# TOWN OF EAST HAMPTON

April 16, 2020

**Re:** Cohen/Tepper Lot Line Modification  
SCTM#300-167-3, 14, 15, 16, & 17

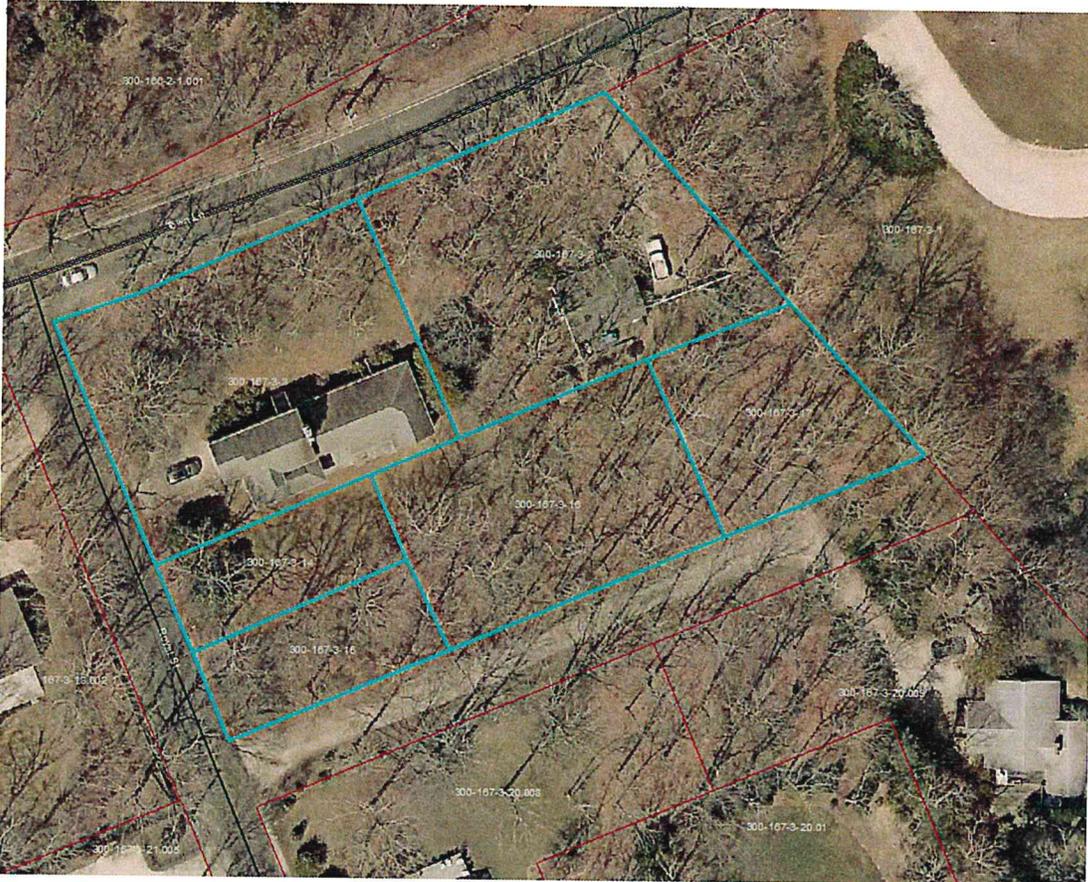
The revised map has incorporated a portion of Underwood Avenue, the urban renewal road on the southerly side, that is scheduled to be abandoned to the centerline into Lot 2. Lot 2 now meets the minimum lot area requirement of 20,000 sq. ft. after excluding the area of the required road widening easement and meets zoning. This abandonment is consistent with the current urban renewal map.

The applicant proposes to revise the point of access designated on the urban renewal map from Royal Street to Underwood Avenue. The Planning Department notes that this will allow for use of an access that is already opened and eliminate the need for clearing a second, parallel access. The Town Board will need to determine whether to modify the access point on the urban renewal map as proposed. The Board should discuss whether it supports this request.
